SEISMIC AND STRESS ANALYSIS OF  
HIGH PRESSURE CORE SPRAY  
SUCTION LINE PIPING SYSTEM  
FOR  
LACROSSE BOILING WATER REACTOR (LACBWR)

DAIRYLAND POWER COOPERATIVE

Rev. No.	Date	Item	Reason for Revision
1	2/14/85	Add Addendum 1	Discrepancies between As-analyzed and as-built Configurations

ADDENDUM I  
EVALUATION OF DISCREPANCIES  
DISCOVERED BY LACBWR RESIDENT INSPECTOR BETWEEN  
AS-ANALYZED AND AS-BUILT CONFIGURATIONS

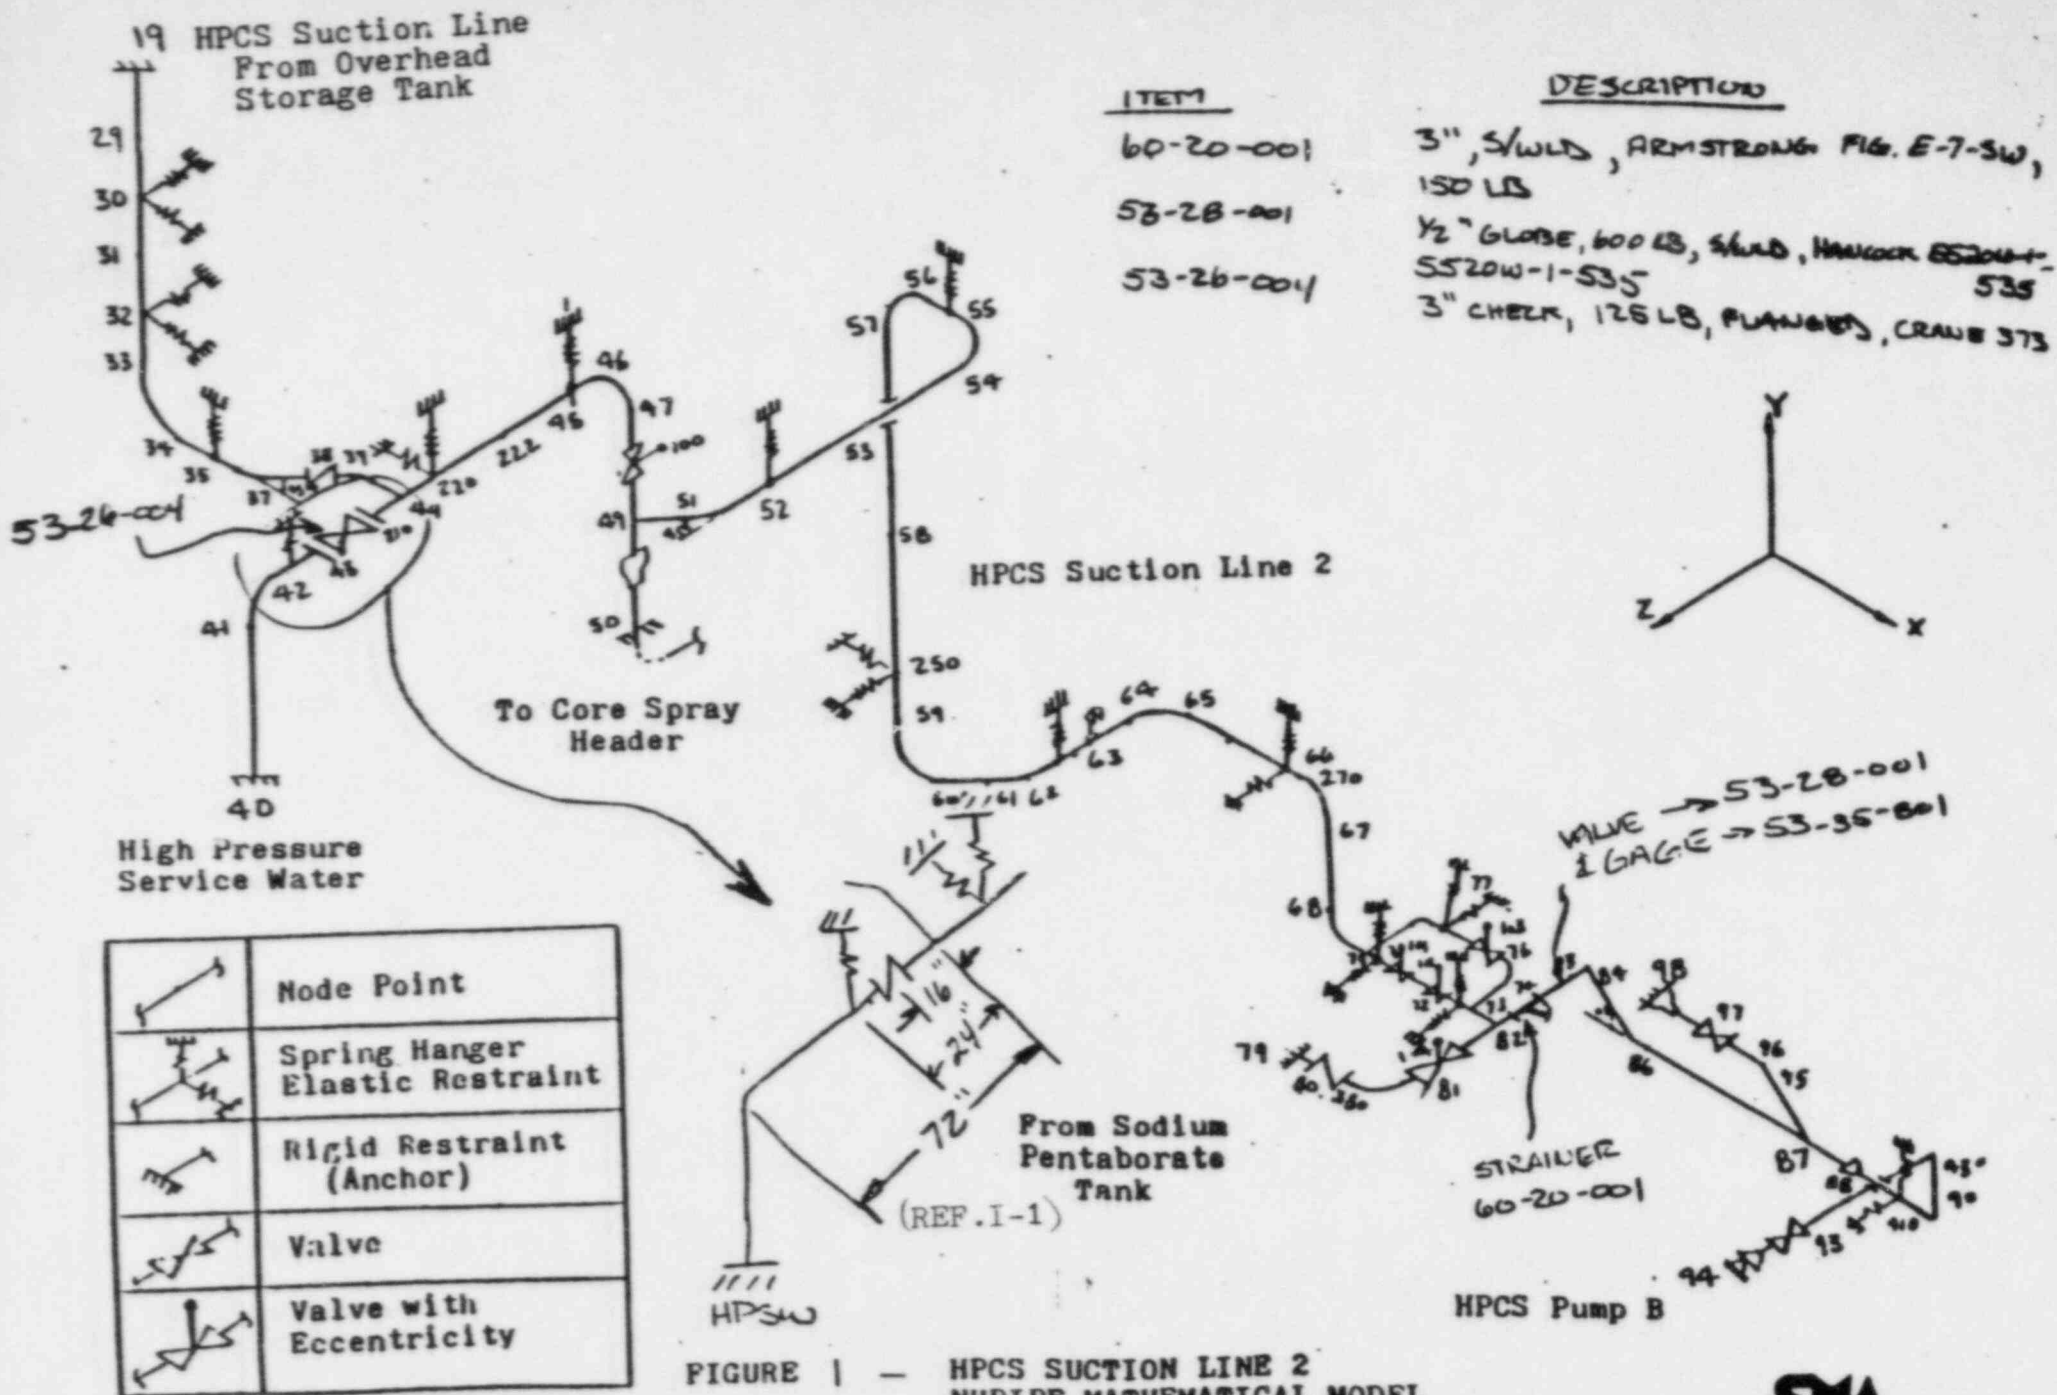
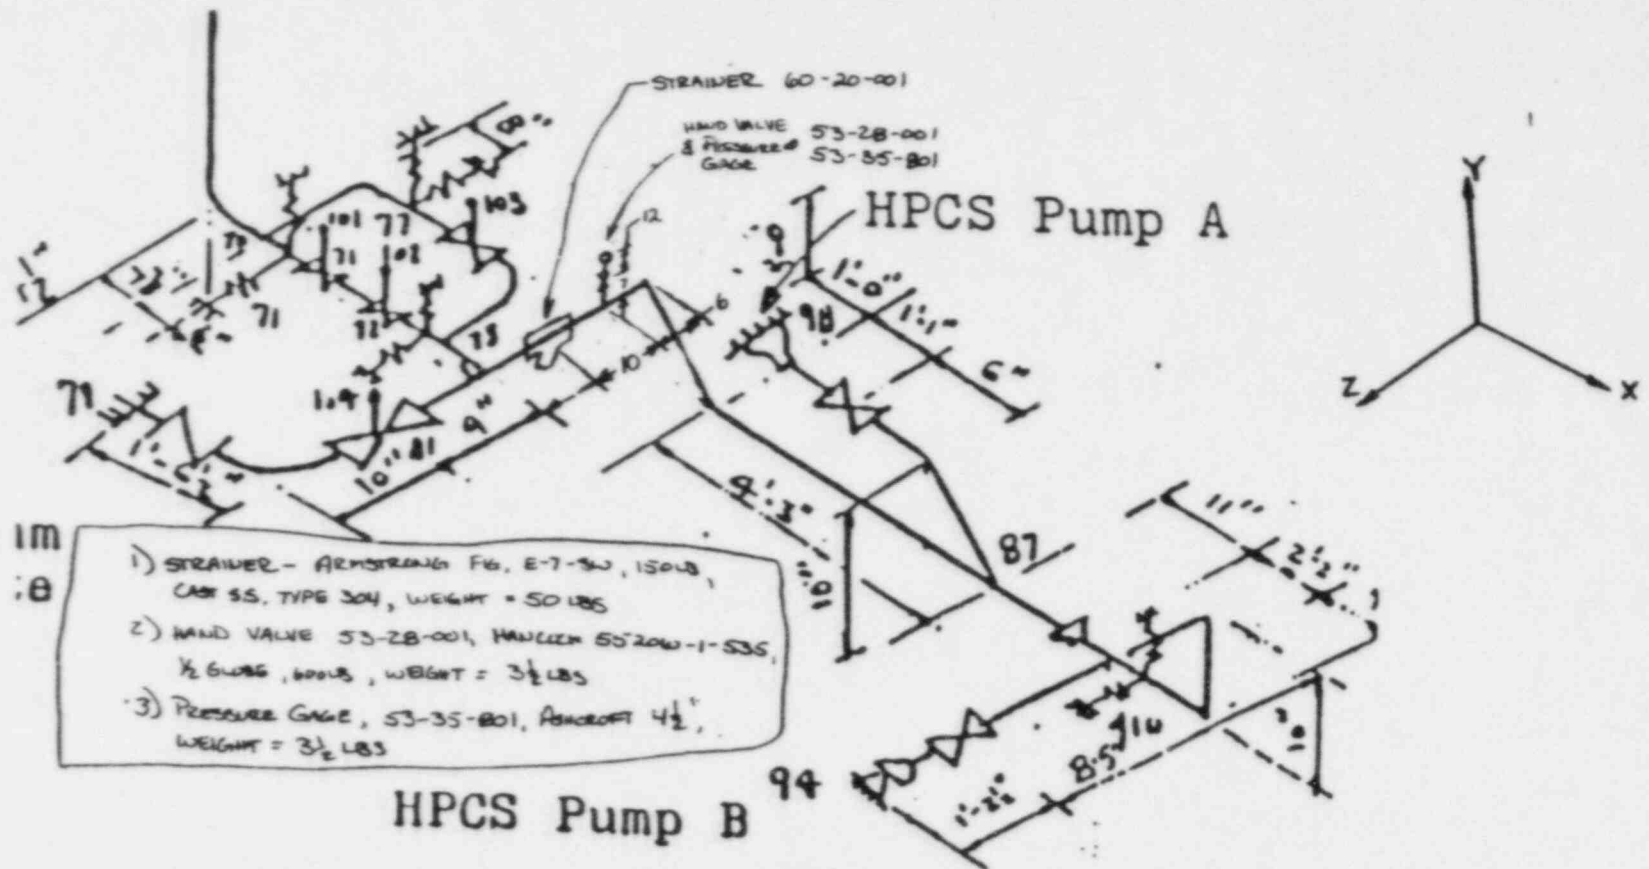
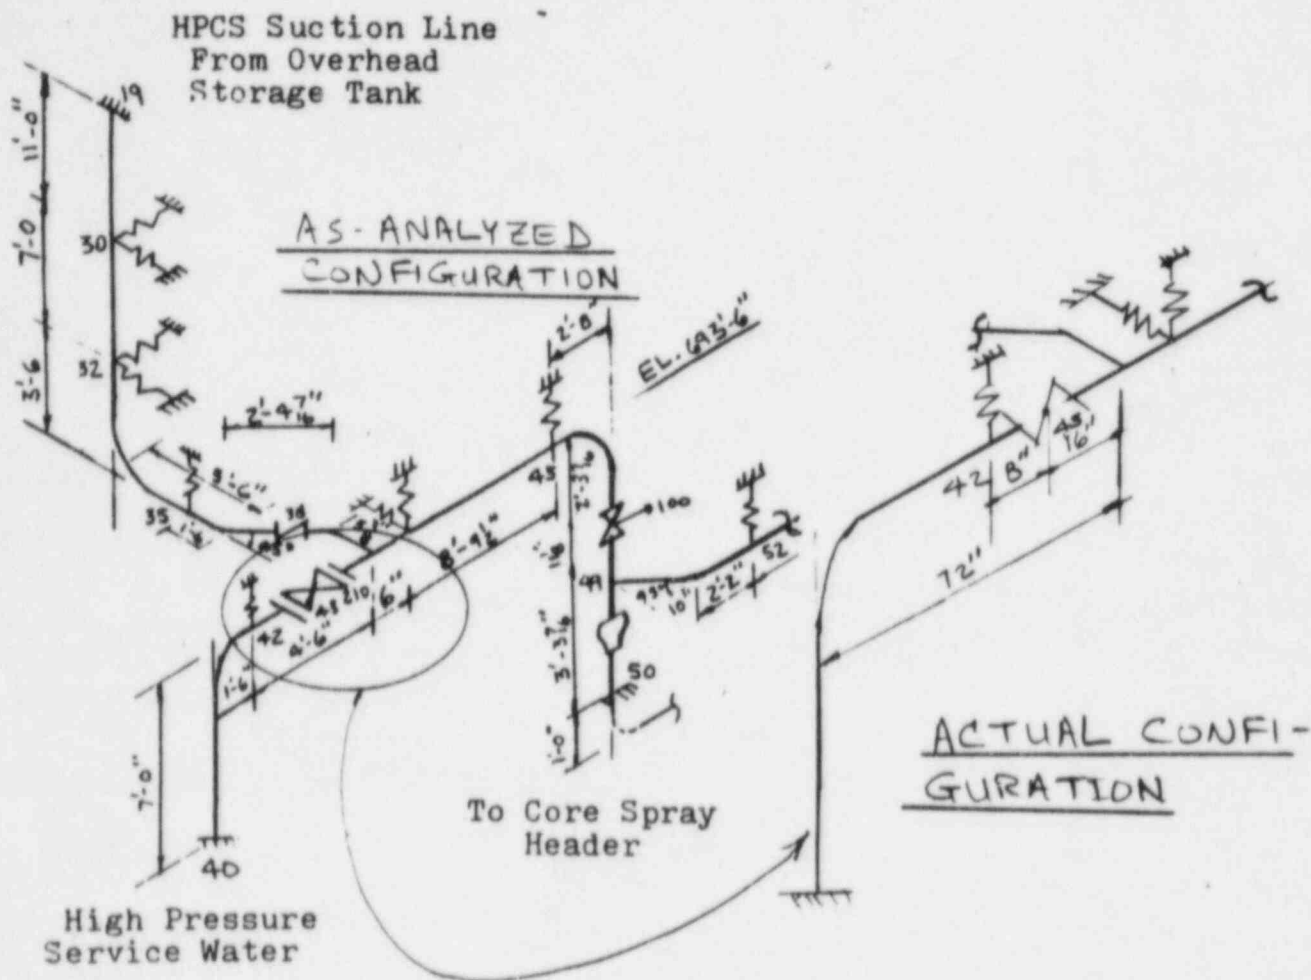
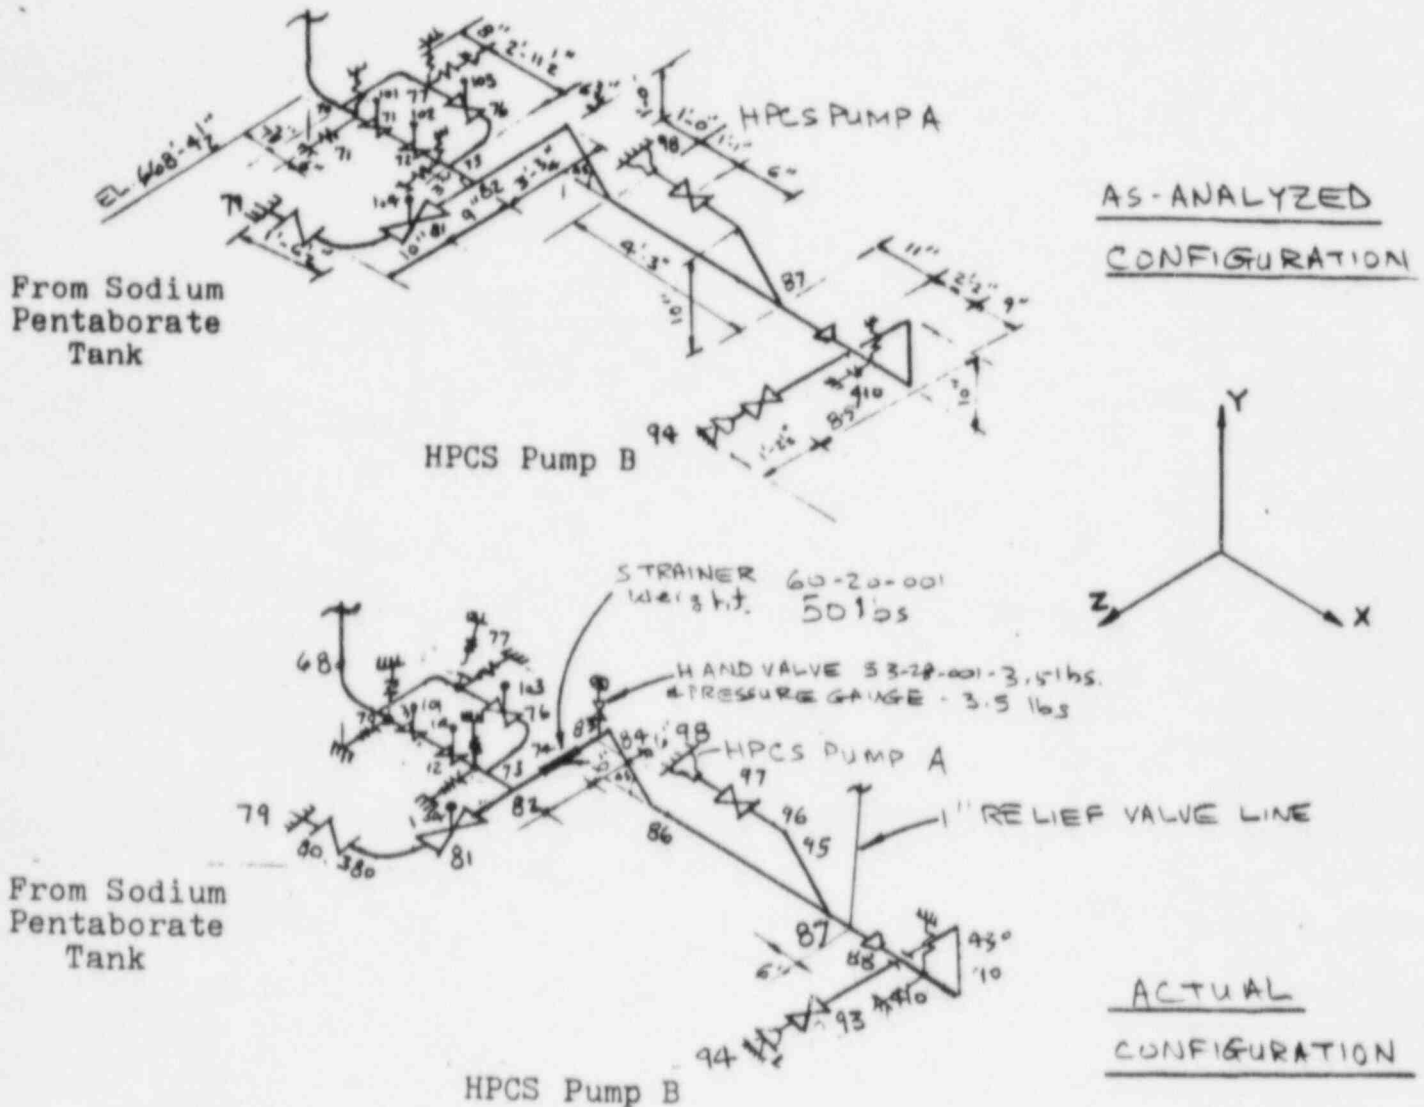
1. Dimensional errors exist between node 41 and 44. The shutoff valve between nodes 43 and 210 is actually a check valve.
2. A 3 inch "Y" type strainer and hand valve with pressure gage was not included in the computer model between node points 82 and 83.
3. The relief valve line from the pump discharge to suction line was not included in the analysis.

Figures 1 and 2 shows the discrepancies. Their effects are discussed in section 3.

AS INDICATED ABOVE, THE VERTICAL SUPPORT IS MOVED CLOSER TO THE CHECK VALVE, THIS WILL REDUCE THE STRESSES IN THE PIPING SYSTEM DUE TO DEAD WEIGHT AND VERTICAL SEISMIC LOAD. THE SUPPORT REACTION LOAD WILL INCREASE HOWEVER THERE IS ENOUGH MARGIN IN THE SUPPORT DESIGN TO ACCOMMODATE THE SLIGHT INCREASE IN THE REACTION LOAD.

AS THE VALVE WEIGHT USED IN THE ANALYSIS IS CORRECT, THERE WILL BE NO EFFECT OF CHANGING THE SHUTOFF VALVE TO A CHECK VALVE.
